Permit Reviews

City of Waukesha

Permit Number: BLR121-00350

Description: Basement Alteration

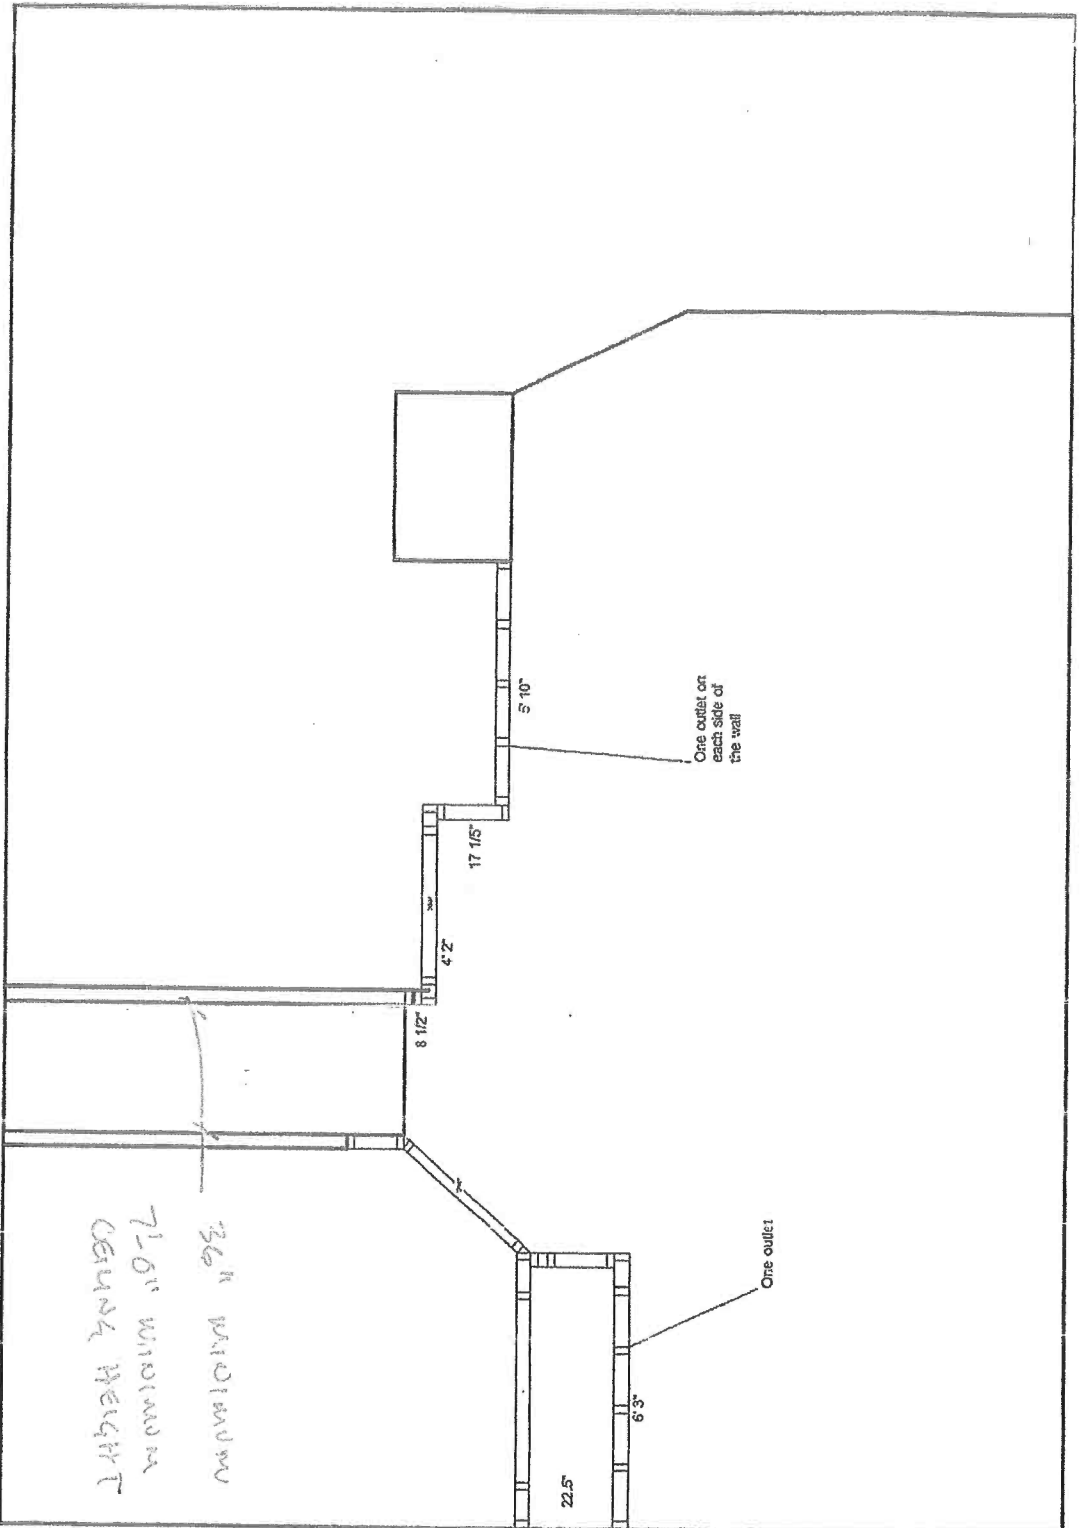
Your recent application for building permit has been **CONDITIONALLY APPROVED** subject to the following limitations and/or requirements listed below. This review and approval does not include any electrical, HVAC, Fire-Protection, or plumbing systems.

- Provide inspector with the Optional Uniform Code Makeup and Combustion Air Worksheet
- All work in accordance with City of Waukesha Municipal Code and Wisconsin Uniform Dwelling Code.
- Install hardwired smoke and carbon monoxide detectors per SPS 321.09 and 321.097
- Install insulation in newly constructed frame walls in accordance with SPS 322.32.
- Stairs must conform to SPS 321.04 – minimum 36" width, minimum tread 9", maximum riser 8"
- Mechanical room enclosure must comply with code and manufacturer specifications for clearances and allowable volume
- Window used for exiting must be no more than 60" above floor. Openings greater than 46" above the floor must have a permanent platform or fixture installed measuring at least 20" wide by 9" deep, located no more than 46" below the clear opening.

- Windows used for exiting must maintain a clear opening of 20"x24" per SPS 321.03(6)
- A non-rigid sheet vapor retarder with a perm rating of 0.1 or less is prohibited on insulated frame wall construction in front of a concrete or masonry wall which is below grade to any extent per SPS 322.38(4)(b).

- Ceiling height per SPS 321.06 must be 7' 0" min for 50% of habitable area with a max. 8" encroachment by beams and/or ducts.
- Fire blocking shall be installed per SPS 321.085 (at all floor penetrations and vertical/ horizontal intersections in concealed spaces.) Expanding foam is not permitted in this application.

- Treated/decay resistant bottom plate shall be used where applicable per SPS 321.10
- Provide all bathrooms with exhaust ventilation capable of exhausting 50cfm/min intermittently or 20cfm/min continuously.

- -Natural ventilation shall be provided to each habitable room by means of openable windows. The net area of the openable windows shall be at least 3.5% of the net floor area of the room. Balanced mechanical ventilation may be provided in lieu of openable windows provided the system can provide at least one air change per hour of fresh outside air while the room is occupied. Infiltration may not be considered as make-up air for balancing purposes, per SPS 321.05(2)

- A Balance Report shall be provided if required for mechanical ventilation.
- Separate permits required for any electrical, plumbing, and HVAC modifications.

- Contact inspector for rough, insulation, and final inspections.

SPS 321.05 Natural ventilation shall be provided to each habitable room by means of operable windows. The net area of the operable windows shall be at least 3.5% of the net floor area of the room. SPS 321.05(2) Balanced mechanical ventilation may be provided in lieu of operable windows provided the system can provide at least one air change per hour of fresh outside air while the room is occupied. Infiltration may not be considered as make-up air for balancing purposes.
